Re: Nusenda Credit Union
2801 Juan Tabo Blvd. NE
30-Day Temporary Certificate of Occupancy
Transportation Development Final Inspection
Architect's Stamp dated 10-26-22 (H21-D020)
Certification dated 09-12-24

Re: Building permit no. BP-2023-11751: New Branch office for Nusenda Credit Union at 2801 Juan Tabo NE, Abq NM.

Transportation Certification Letter

sheet: A001

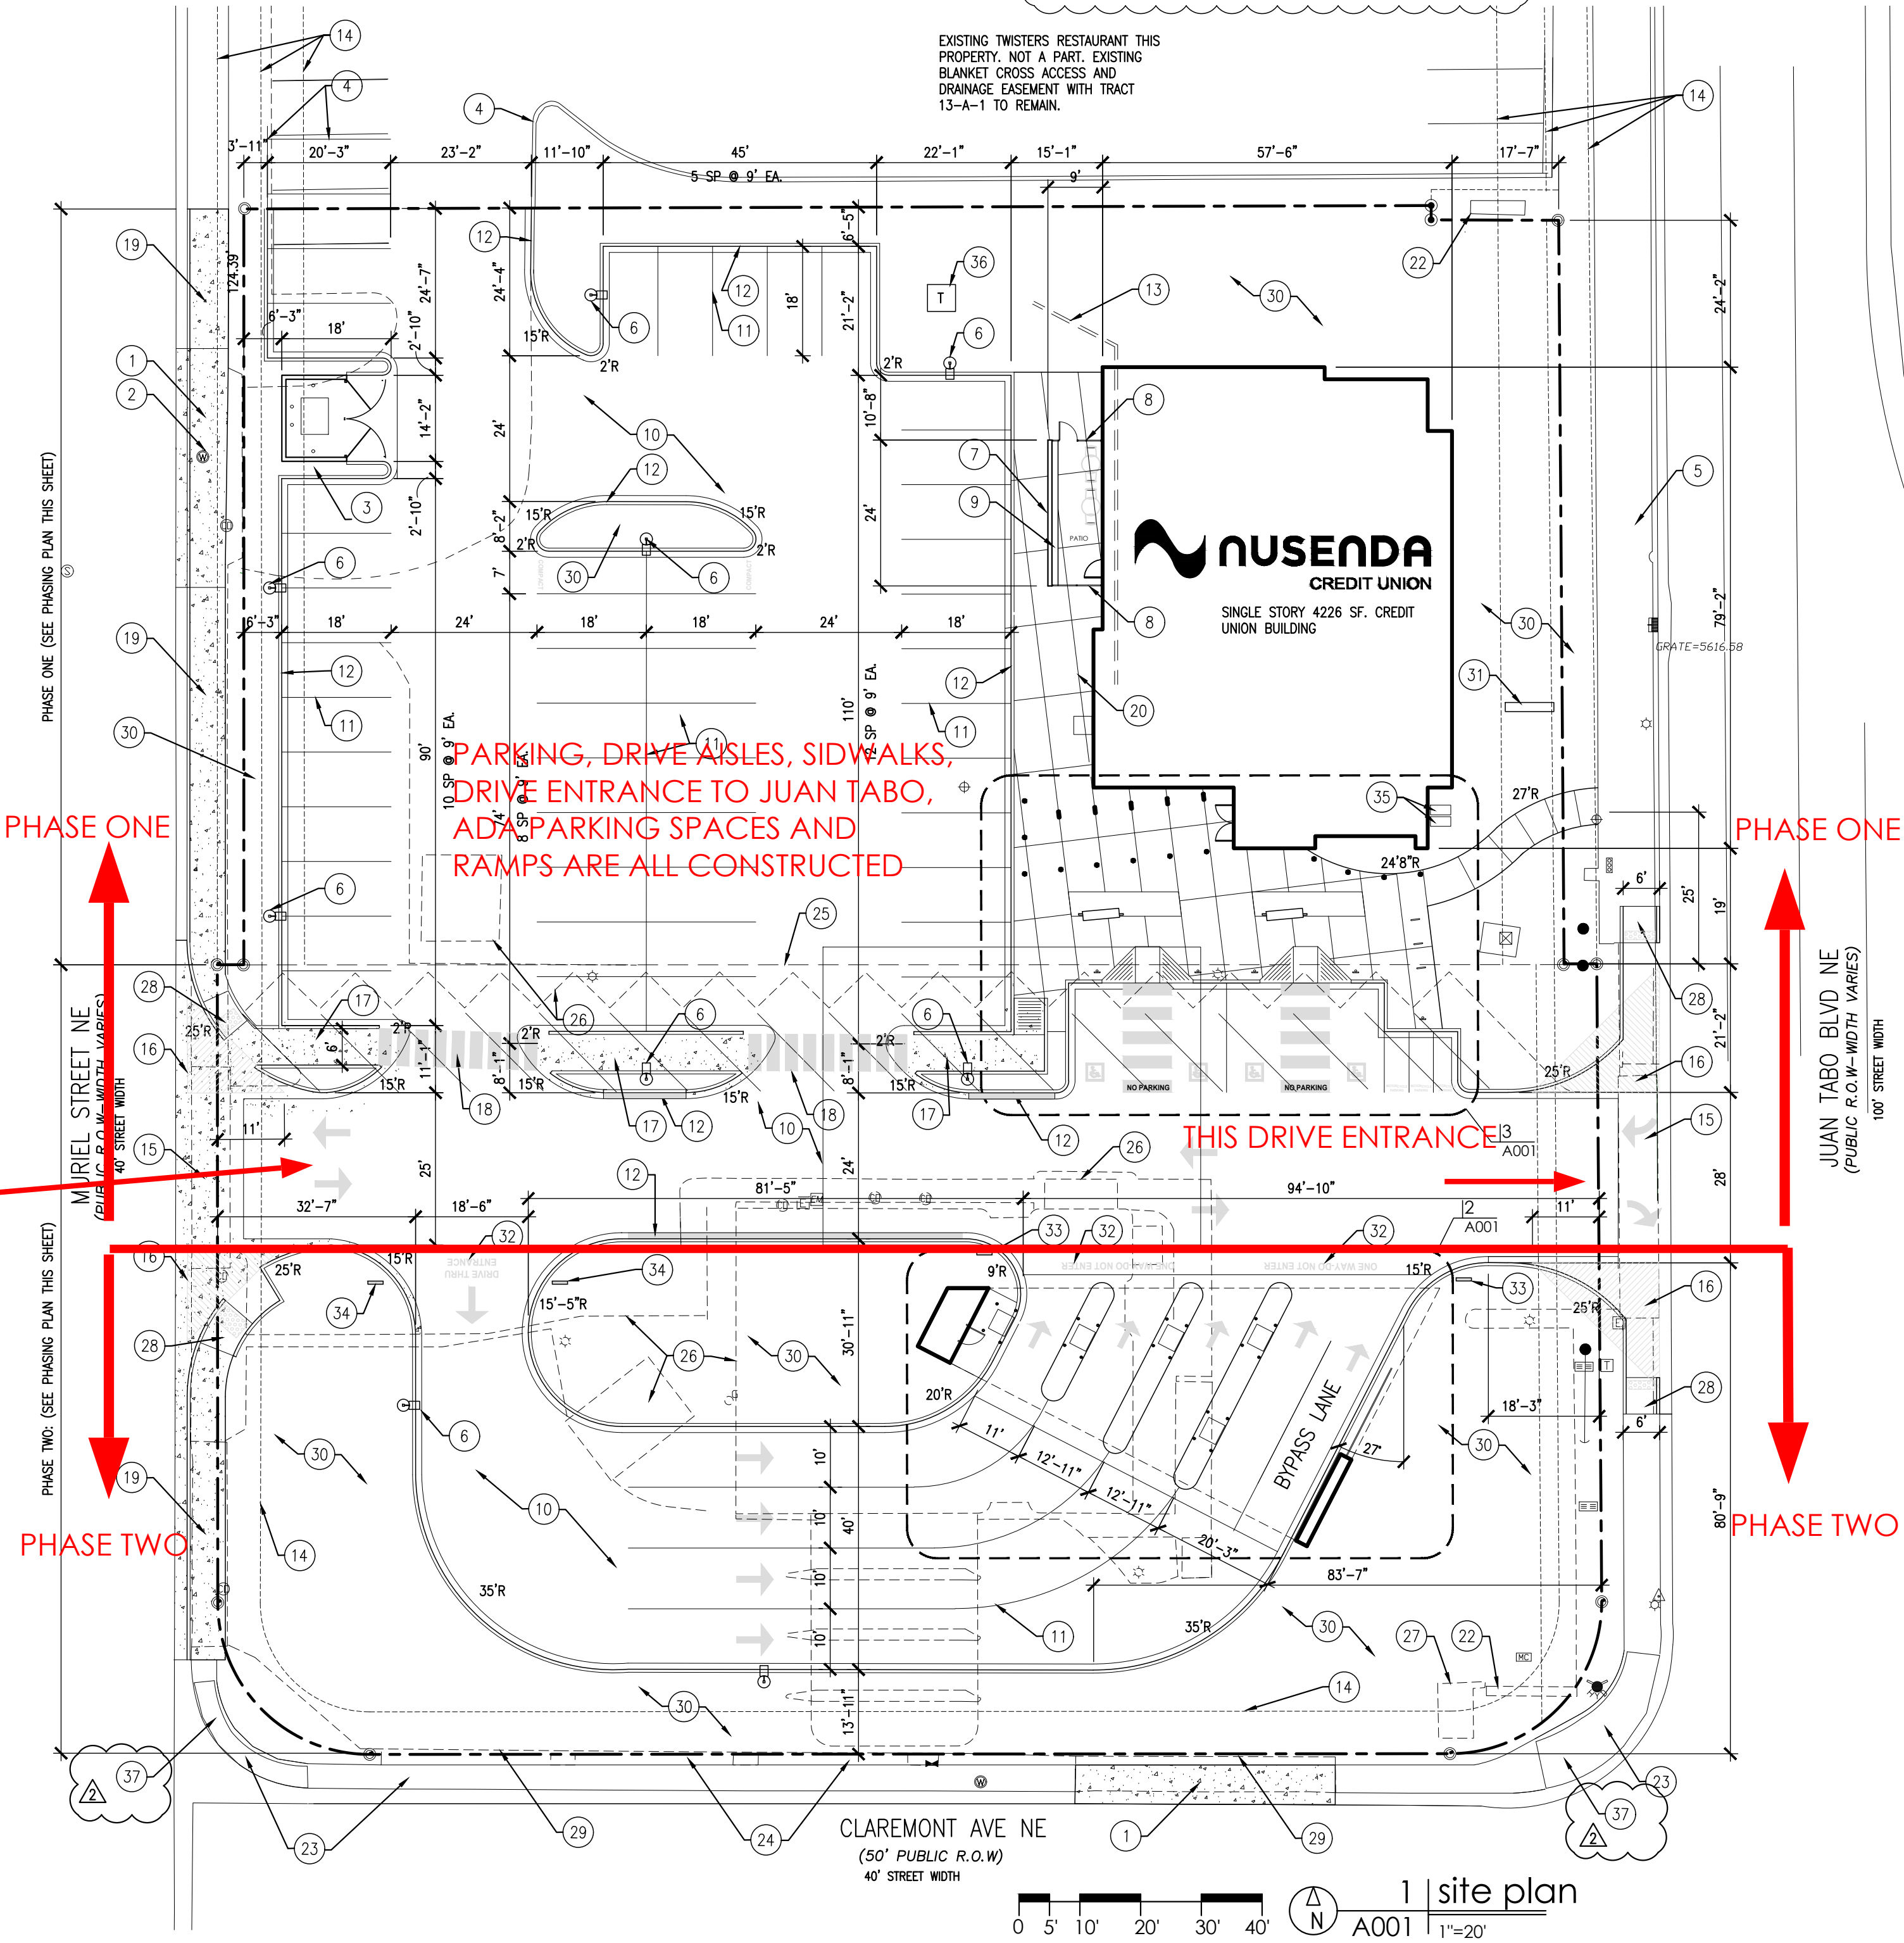
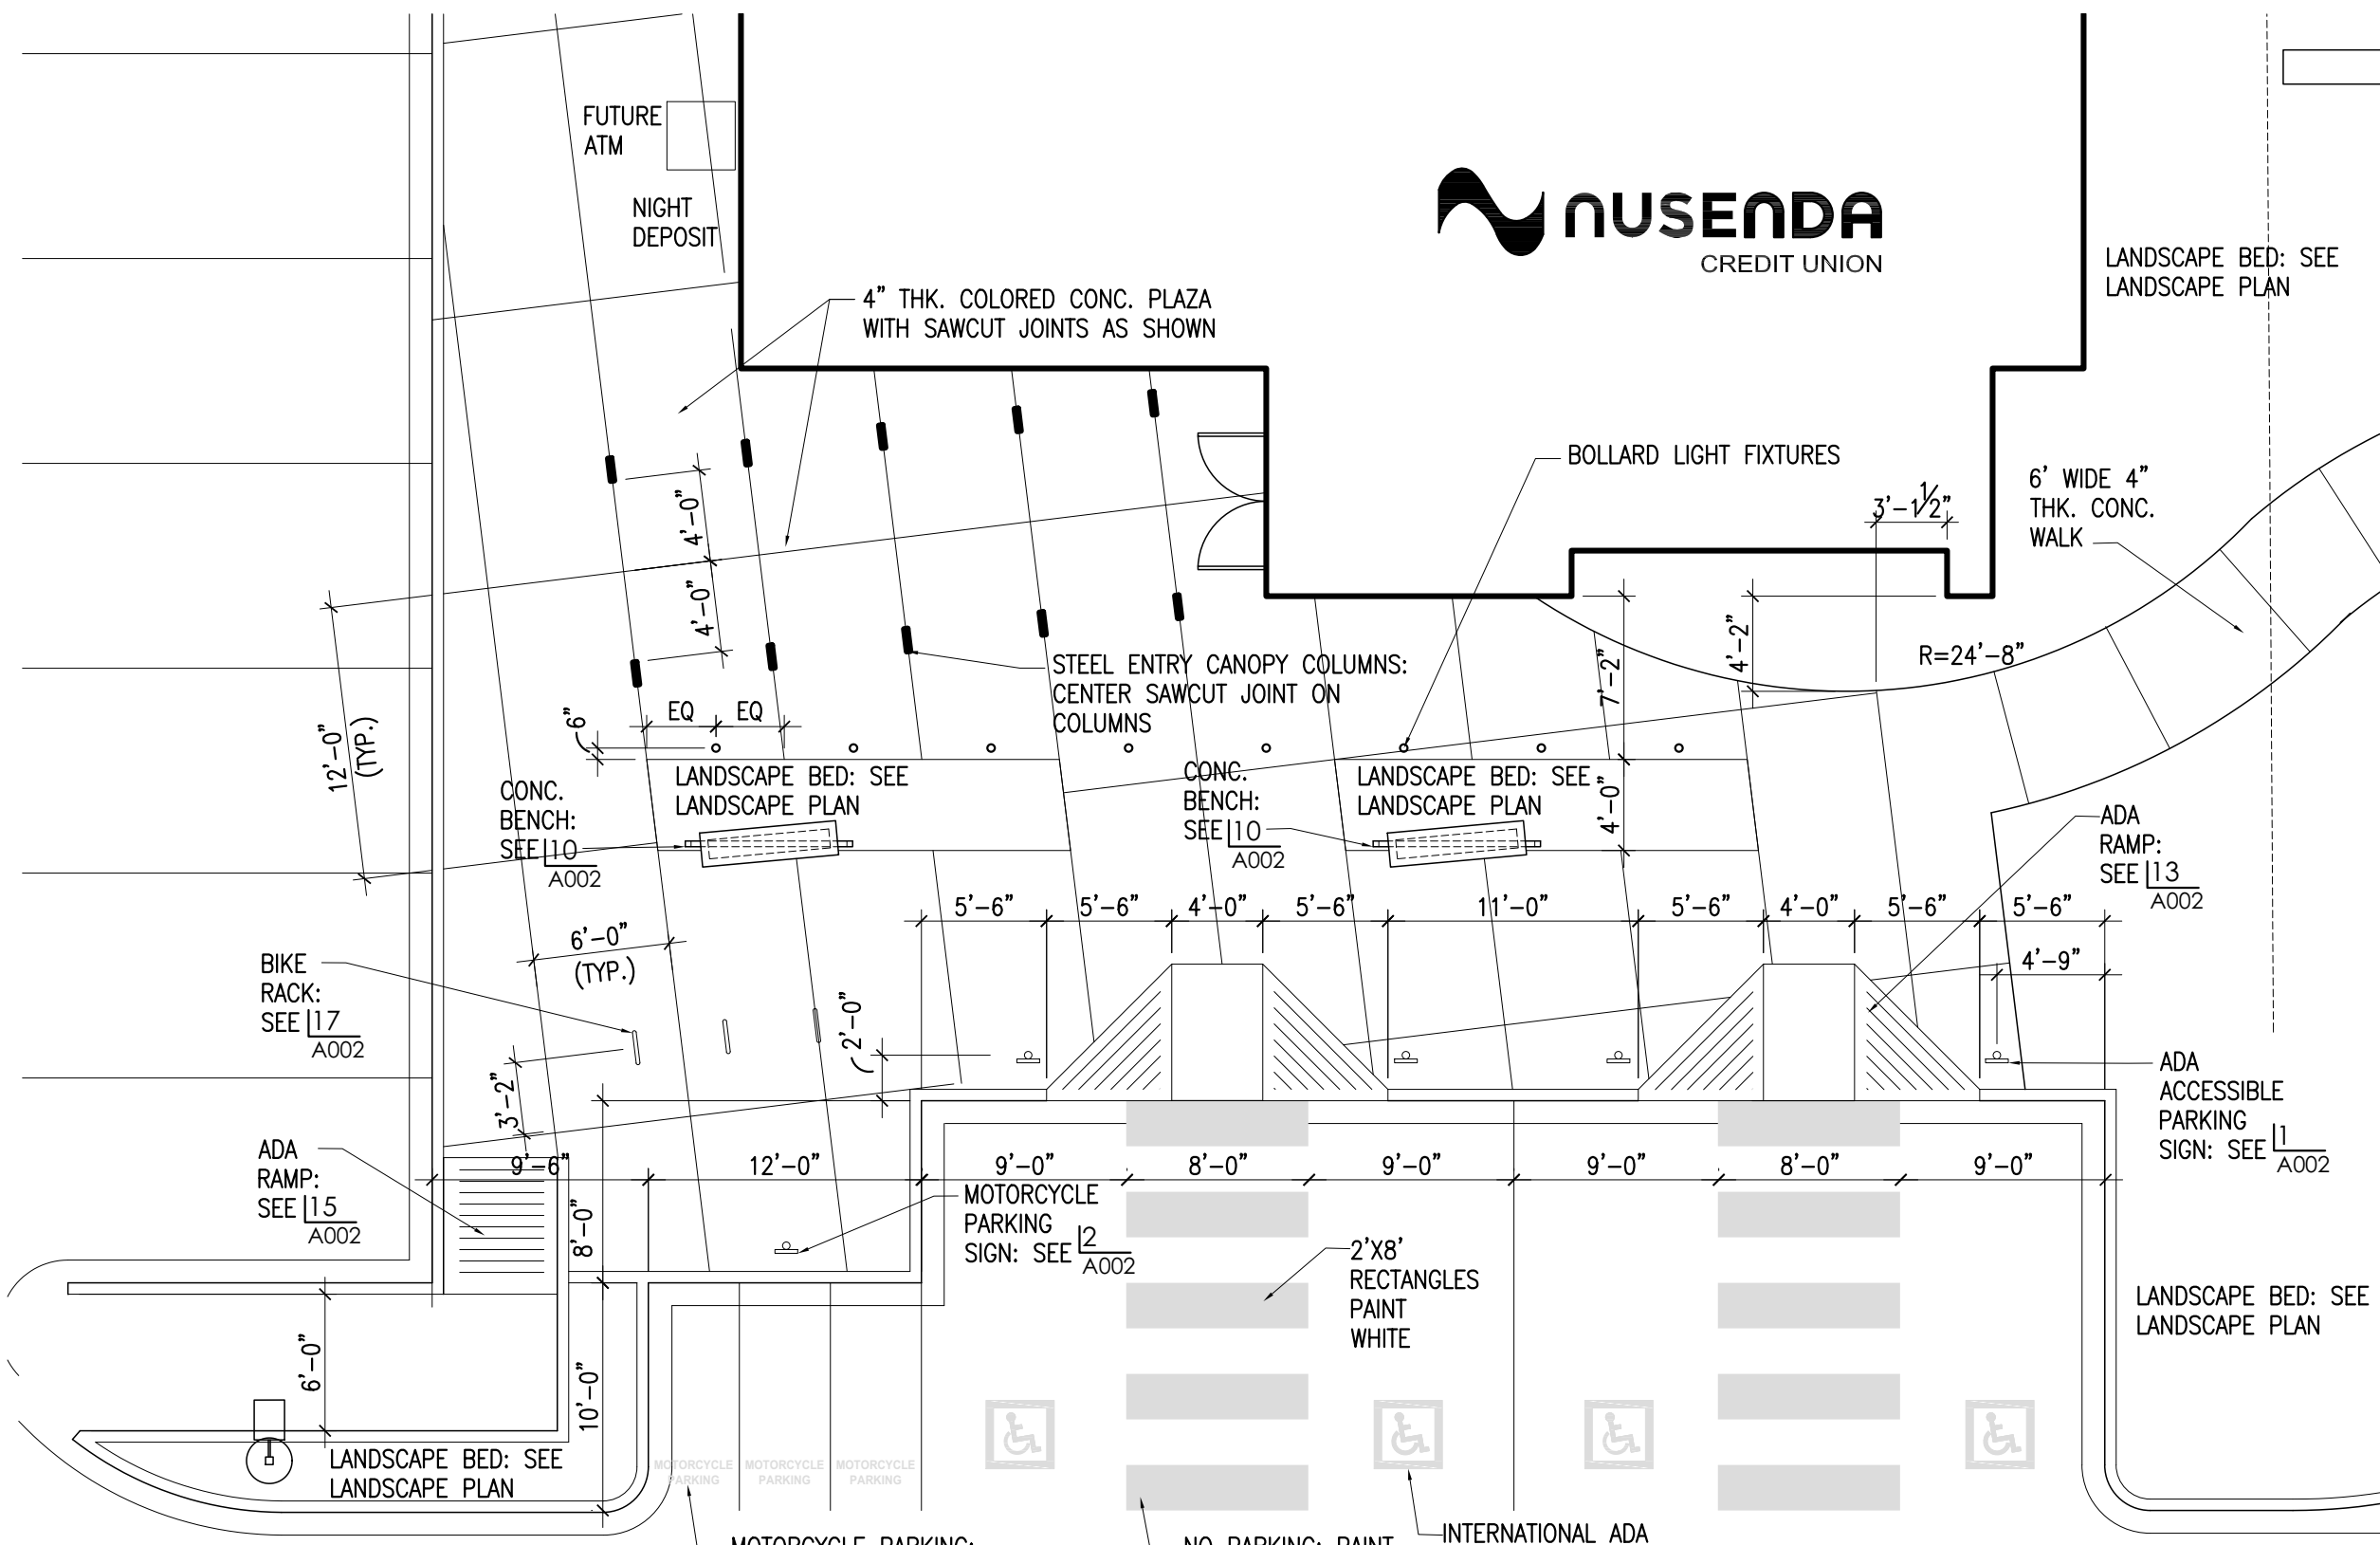
- A Truncated Domes must be installed at the corner ramp of Juan Tabo Blvd and Claremont Ave.
- The city right of way ramp at the corner of Claremont Ave and Muriel St. must be updated to the current ADA standard and truncated domes must be installed. Per site visit the corner ramp width was 3 ft. the minimum width should be 4 ft.

- Prior to issue a Perm CO, the construction of the site access off Muriel St. must be completed.

- Per approved site plan, Unused curb cuts must be replaced with sidewalk and curb & gutter. A build note must be provided referring to the appropriate City Standard drawing.

- Per approved site plan “All broken or cracked sidewalk must be replaced with sidewalk and curb & gutter.” A build note must be provided referring to the appropriate City Standard drawing. Broken sidewalk off Juan Tabo must be fixed.

- Anchor down bike rack.
- Motorcycle parking signs must be installed.

1 site plan
A001 1"=20'

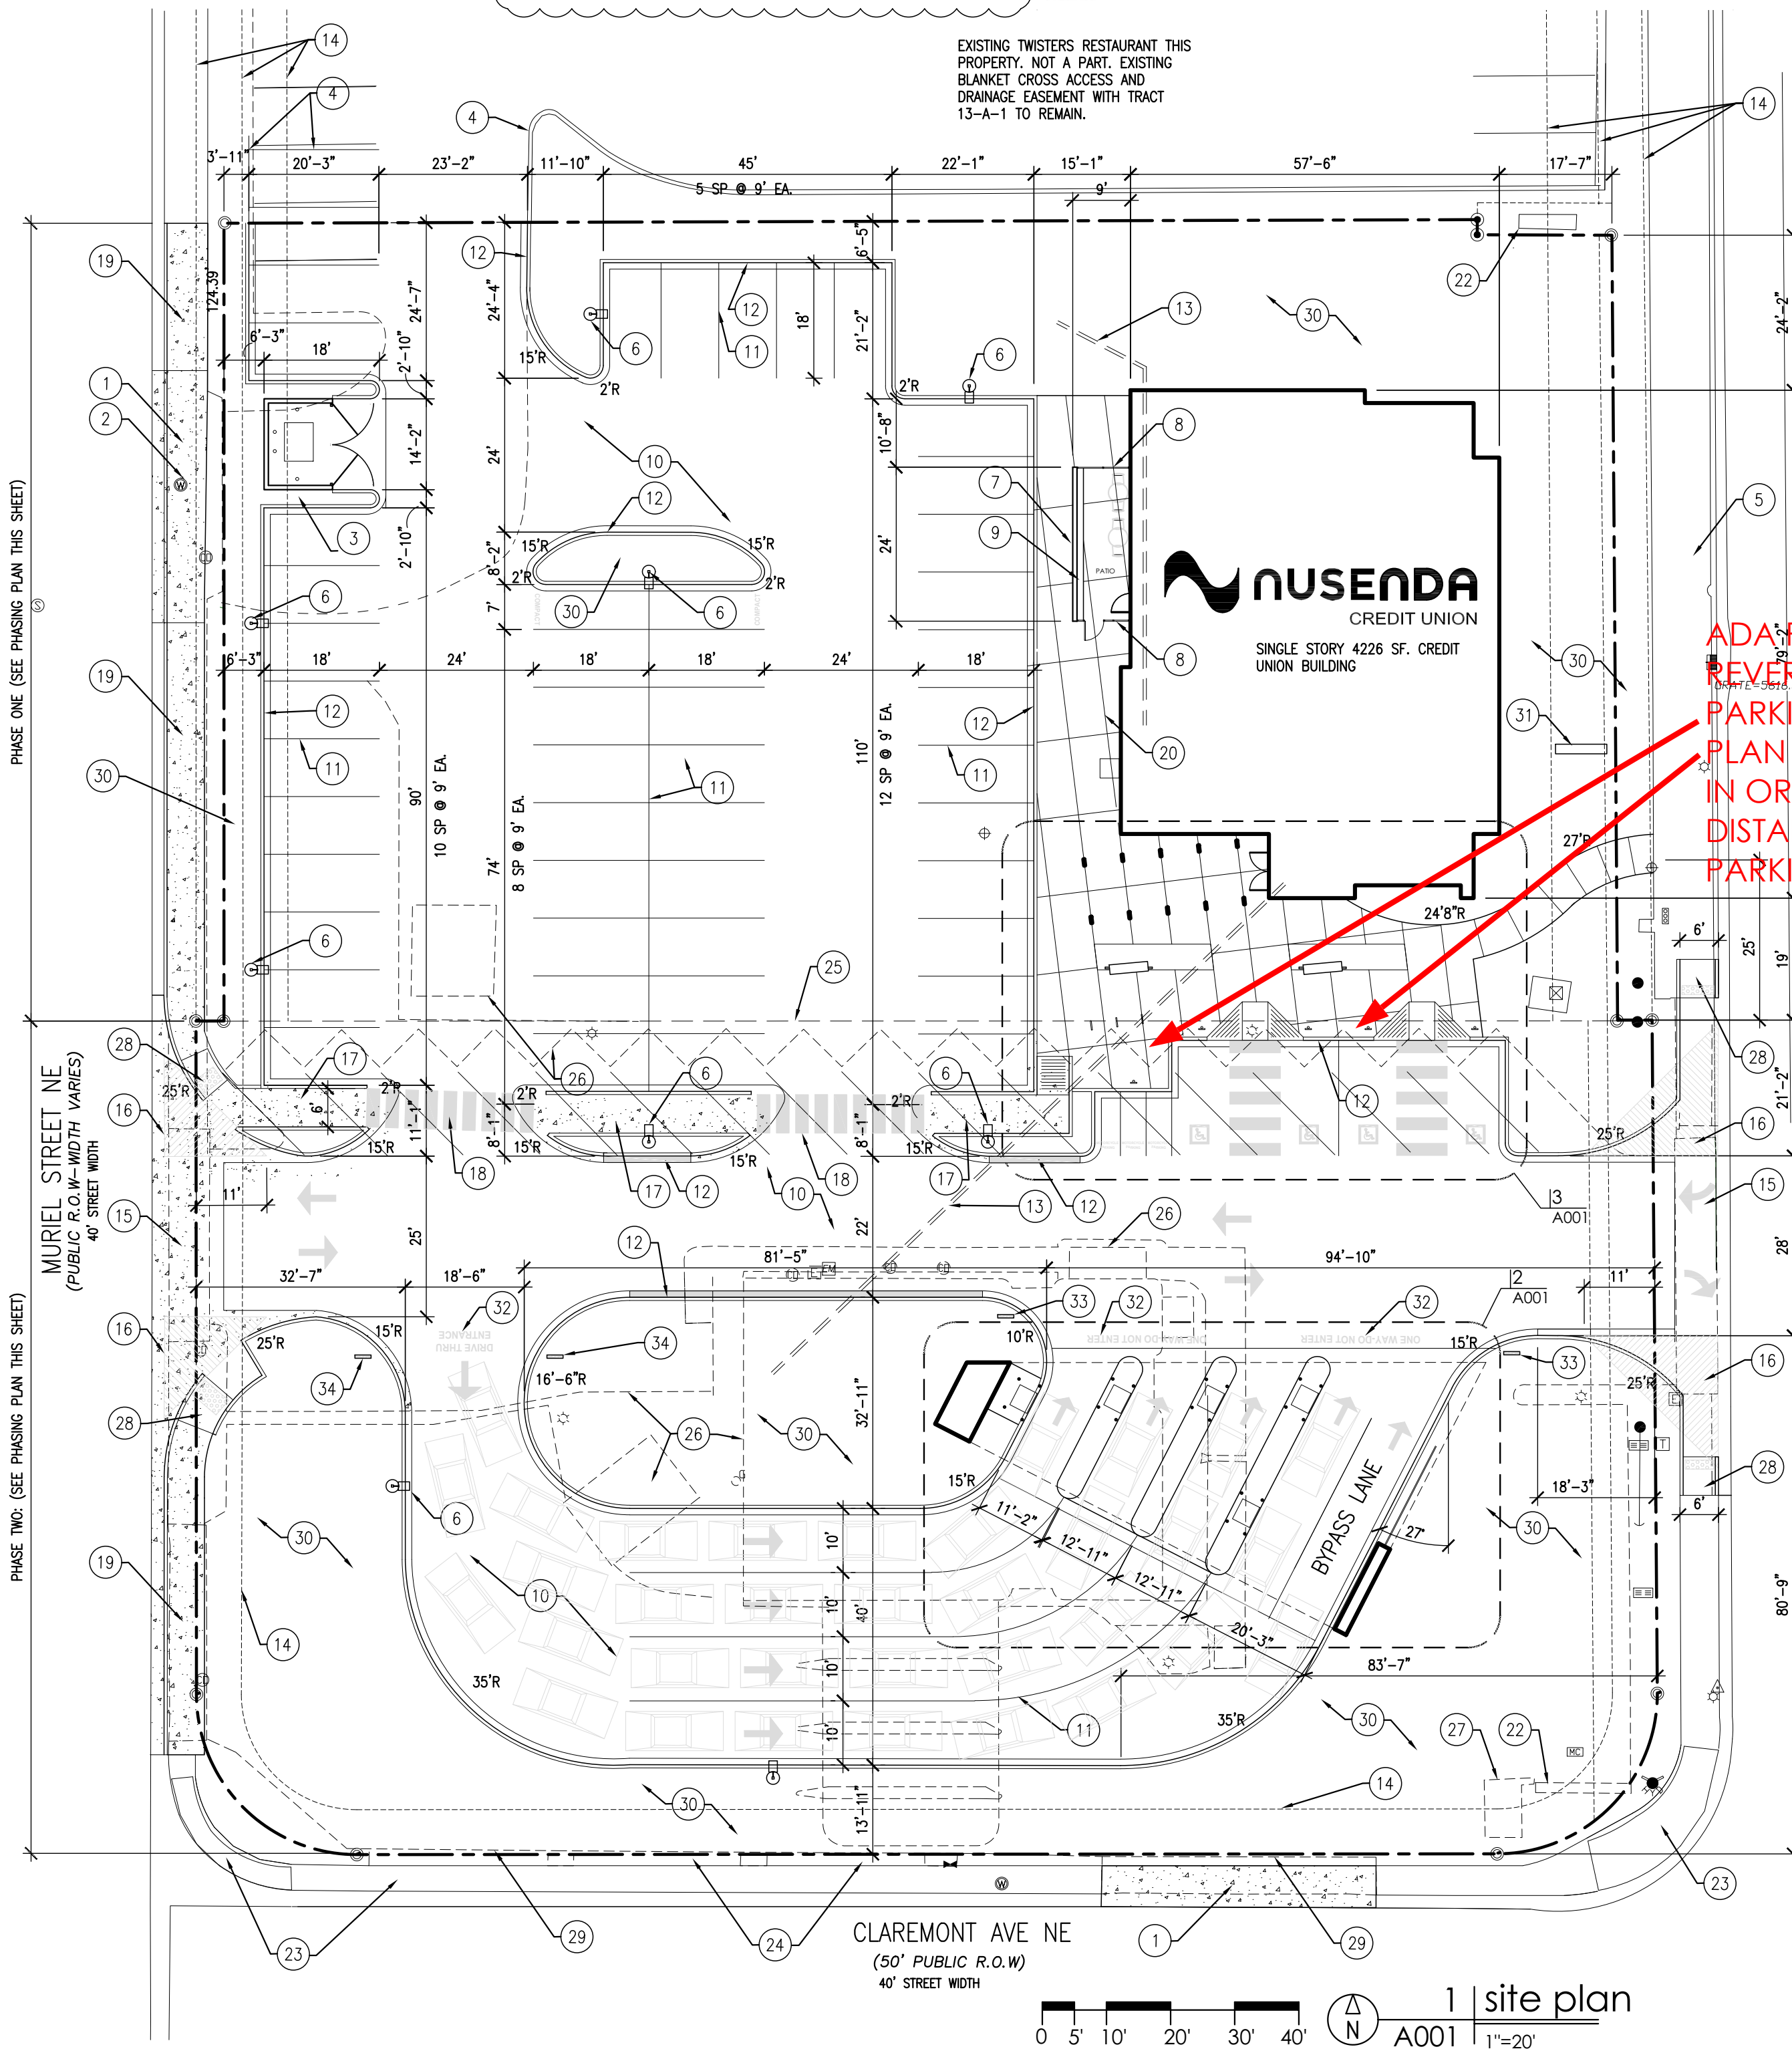
ADA PARKING SPACES WERE REVERSED WITH MOTORCYCLE PARKING AS SHOWN ON THIS PLAN DURING CONSTRUCTION IN ORDER TO REDUCE THE DISTANCE FROM THE ADA PARKING TO THE ENTRANCE. SEE
